INDESIT company

ASL70CEX

F030645

Notices

n1040358: Introduction of front bearing pads.

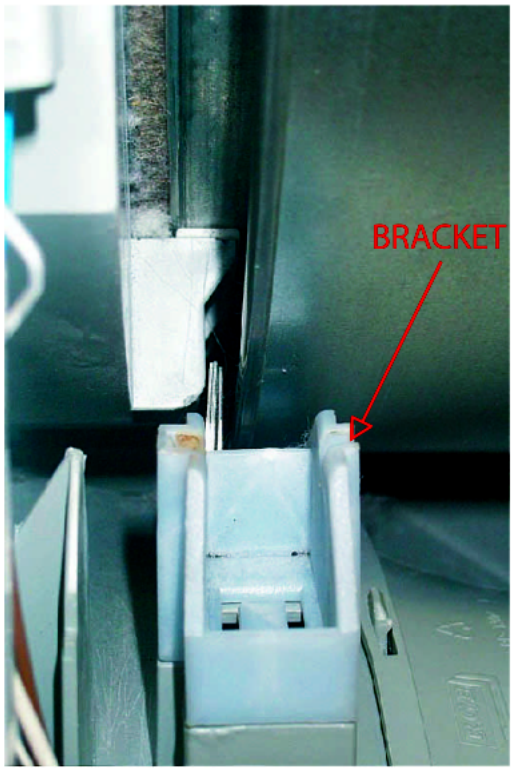
Convert drum front support to run on bearing pads.
Remove the two wheels supporting the drum front from their locating brackets but leaving the two brackets attached to the base assembly. See N1040358FIG1.
Remove the front panel and air duct assembly and fit 5 bearing pads into the locating slots on the air duct assembly. See N1040358FIG2. Replace both the rear bearing and the drive belt to the 6 rib version.

As from s/n 50131.0001 the front suspension changed on production of all condenser dryers from wheels to bearing pads as described above.

Parts needed:
5 X Front Bearing pad code C00112144 item 350
1 X Rear Bearing code C00113862 item 503
1 X Belt code C00116358 item 556

The above parts are available in the kit code C00118931.

n1040369: Sensor, heating element and thermostat modified on condenser dryers.

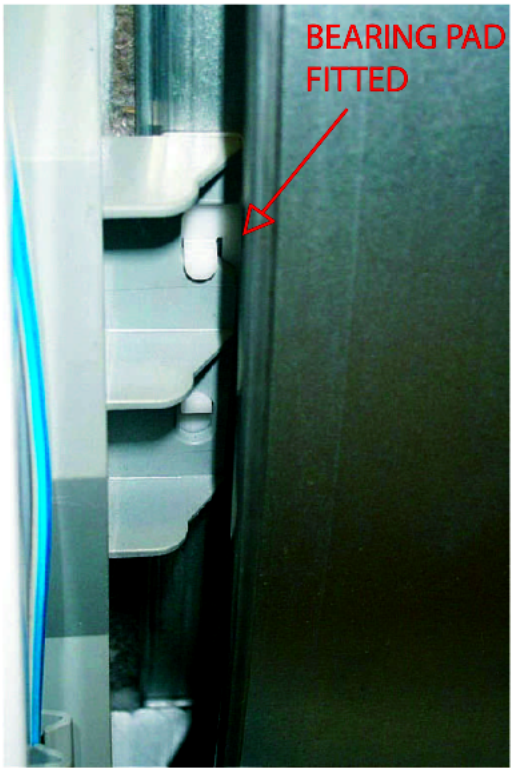
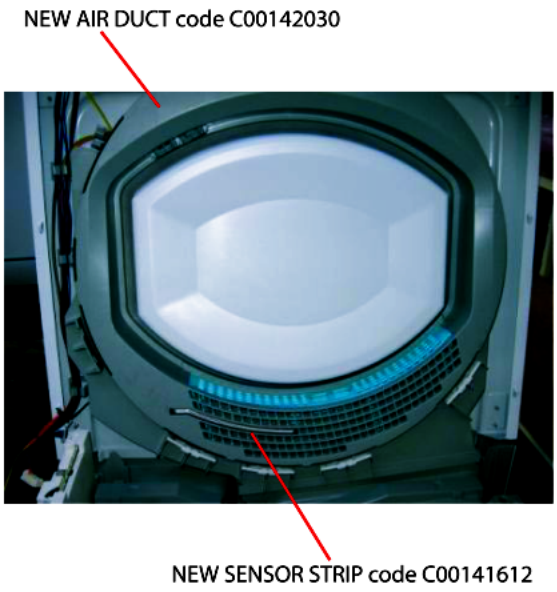
From serial no. 50712.0001, the following parts have been introduced progressively on condenser dryers:
- new sensor (figure N1040369FIG1);
- new heating element;
- new thermostat.

The eeprom and circuit diagram were also affected by the modification (Figure N1040369FIG2).

The new items are not interchangeable with the premodification ones.

New parts:
C00142030 - front air duct - (ref.330)
C00141612 - sensor strip - (ref.330)
C00141607 - drum support (there are 2 on all dryers) - (ref.545)
C00142303 - heating element - (ref.522)
C00142302 - heating element for ASL70CSK - (ref.522)
C00142587 - heating element for ISL70CSK - (ref.522)
C00141606 - thermostat kit - (ref.521)
C00142300 - thermostat kit for ASL70CSK - (ref.521)

premodification parts:
C00113855 - front air duct - (ref.330)
C00113817 - sensor brush - (ref.533)
C00113816 - brush bracket - (ref.533)
C00113838 - insulating material for sensor strip - (ref.538)
C00113837 - sensor band - (ref.539)
C00112186 - drum support - (ref.545)
C00113836 - sensor brush bracket - (ref.546)
C00115746 - heating element - (ref.522)
C00116600 - heating element for ASL70CSK / ISL70CSK - (ref.522)
C00116598 - thermostat kit - (ref.521)

n1040400: Bearing pad removed from condenser dryers.

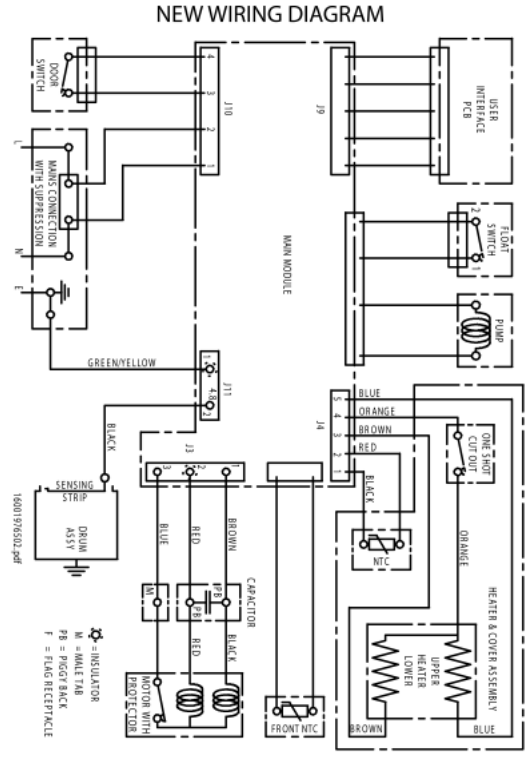
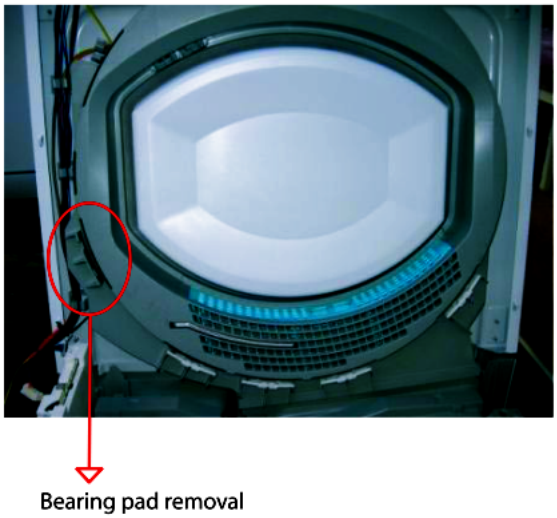
From serial no. 51031.0001, four bearing pads (C00112144) have been installed on dryers instead of five (see figure N1040401FIG1).

From 30.01.10 the front air duct assembly will be modified by removal of the 5th bearing pad fixing

n1040411: Modifications of heating elements/thermostats on condenser dryers.

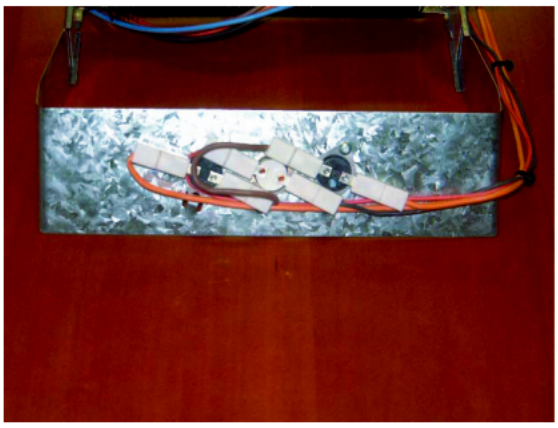
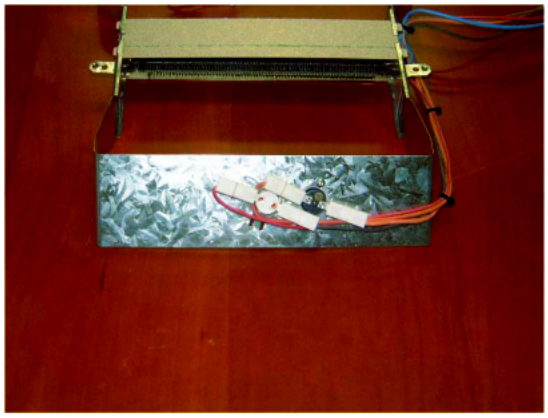
1) All appliances with serial number prior to 50712.0001 are equipped with a heating element assembly (fig1) with the following thermostats:
a) one-shot
b) cycling
c) ntc

2) From serial no. 50712.0001 the cycling thermostat has been eliminated, the heating element assembly (fig.2) is composed of the following thermostats:
a) one-shot
b) ntc

3) From serial no. 51130.0001 the ntc thermostat has been modified, the modification also introduced a new eeprom with software 28XXXXX0008, the heating element assembly (fig.2) is composed of the following thermostats:
a) one-shot
b) ntc (Tod)

4) From serial no. 60109.0001 the cycling thermostat has been reintroduced, the heating element assembly (fig.1) is composed of the following thermostats:
a) one-shot
b) cycling
c) ntc (Tod)

Replacement P/Ns for models with serial number prior to 51130.0001:

C00258828 - heating element assembly (with one-shot + cycling + ntc sensor)
C00258813 - heating element assembly (with one-shot + cycling + ntc sensor) for SK dryers
C00116598 - thermostat kit (one-shot + cycling)
C00113830 - ntc thermostat
Important
When replacing the thermostats on models with serial numbers from 50712.0001 to 51130.0001 order the assembled heating element.

Replacement P/Ns for models with serial number subsequent to 51130.0001:
C00258799 - heating element assembly (with one-shot + cycling + new ntc sensor)
C00258800 - heating element assembly (with one-shot + cycling + new ntc sensor) for SK dryers
C00116598 - thermostat kit (one-shot + cycling)
C00143511 - ntc thermostat (new Tod)
Important
When replacing the thermostats on models with serial numbers from 51130.0001 to 60109.0001 order the assembled heating element.
